DESIGN EXCELLENCE REVIEW

KAMIRA AVENUE VILLAWOOD – PPSSWC-281

REV B 17-04-2025

The following provides a statement to assist the consent authority in determining whether the proposed development DA 303.1/2002 at 2 Kamira Court Villawood exhibits design excellence as required by clause 6.12 of Fairfield Local Environmental Plan 2013.

FIGURE 3: ALTERNATIVE MASTERPLAN

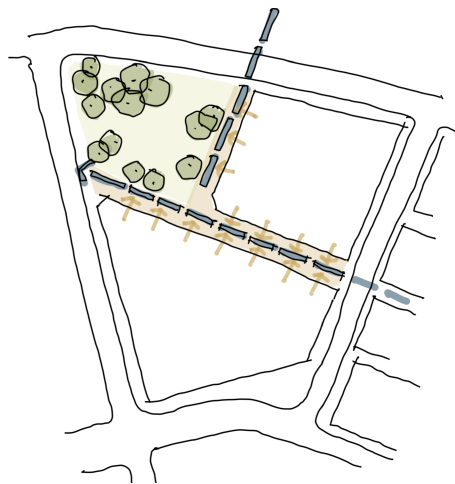
Could there be an alternative that resolves the conflict

A better masterplan alternative could have been to move the park to the corner of Villawood and Kamira Avenue. The east-west pedestrian link then creating the southern boundary of the park and defining the north facing façade that could contain retail uses overlooking the park. There would be almost no overshadowing to the park, and the pedestrian area in front of the retail would be in sun throughout the winter. The apartments above would then retain the northern orientation but would have the benefit of being setback further from the railway – reducing the impacts of noise and vibration.

I mention this not because this application should be amended to consider this (that time has long passed, and the application is consistent with the planning controls set for the site) but because masterplan establishes a context that the proposal responds to with respect to the address to Villawood Road, building massing and also the above ground car parking. It also sets up a series of conflicts that need to be resolved in the design.
